Part: SE141-116 / MODULAR COIL WINDING FORM TYPE

Drawing ID: SE141-116 Revision: 8

Rapid response NCR disposition for MCWF C5

65707/5 (C5)
SE141-116

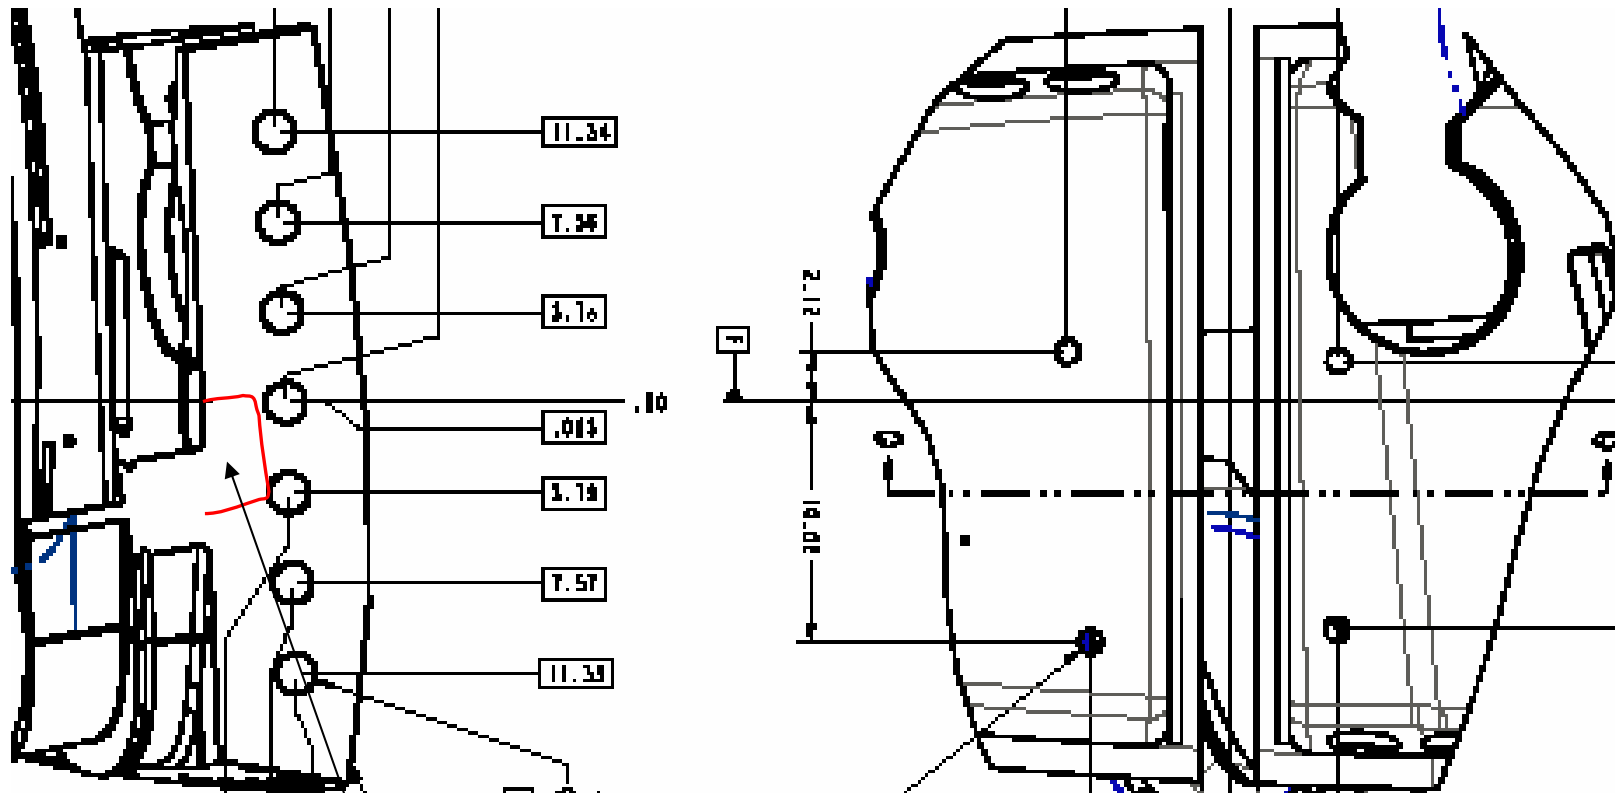
Problem: Sheet 6, zone F2; 1.125 +/- .010 checks 1.025".

Outer portion of poloidal break between the poloidal break flanges was machined off of centerline approximately .100". The inner portion of the break (T section) was machined on location which caused a mismatch in the break surface.

MTM inadvertently undercut the surface of the T by 0.080 inches in C5 as shown in the figure in the attached Rapid Response documentation. A conference call attended by Ray Sheppard of EIO, Mike Griffith of MTM, David Williamson of ORNL, and Phil Heitzenroeder of PPPL was held at approximately 5:30 p.m. on 3/29/06 to discuss this and MTM's proposed resolution. MTM will machine the poloidal break slot width to 2.350 inches rather than 2.250 inches. The cast shim plate will be machined to the 2.350 inch dimension to compensate. Mike Griffith noted that even with this increased slot width the break flange thickness will still be within tolerance.

Flange area of poloidal break finished machined .100" off location to this side.

The area of the T section inward including the area highlight in red has been undercut into this surface approximately .08". This area has been cut on location.

Machine the stock heavy side of the break to the correct location per the drawing. This will blend into the area of the T that is currently undercut. Machine the T section to match the flange surface that was cut off of location (approximately .100"). The slot width will finish at approximately 2.350" rather than 2.250". In order to accommodate the oversized slot, the shim thickness will need to be machined to 2.225 rather than 2.125". The additional .100" of stock will be added to only one surface on the shim and profile machined accordingly. (see attachment)

PROPOSED REPAIR
Machine the left side of the break above to the correct location per the drawing. This will blend into the area of the T that is currently undercut. Machine the T section on the right side of the break to match the flange surface that was cut off of location (approximately .100"). The slot width will finish at 2.350" rather than 2.250". In order to accommodate the oversized slot, the shim thickness will need to be machined to 2.225 rather than 2.125". The additional .100" of stock will be added to only one surface on the shim and profile machined accordingly (see picture on next page).
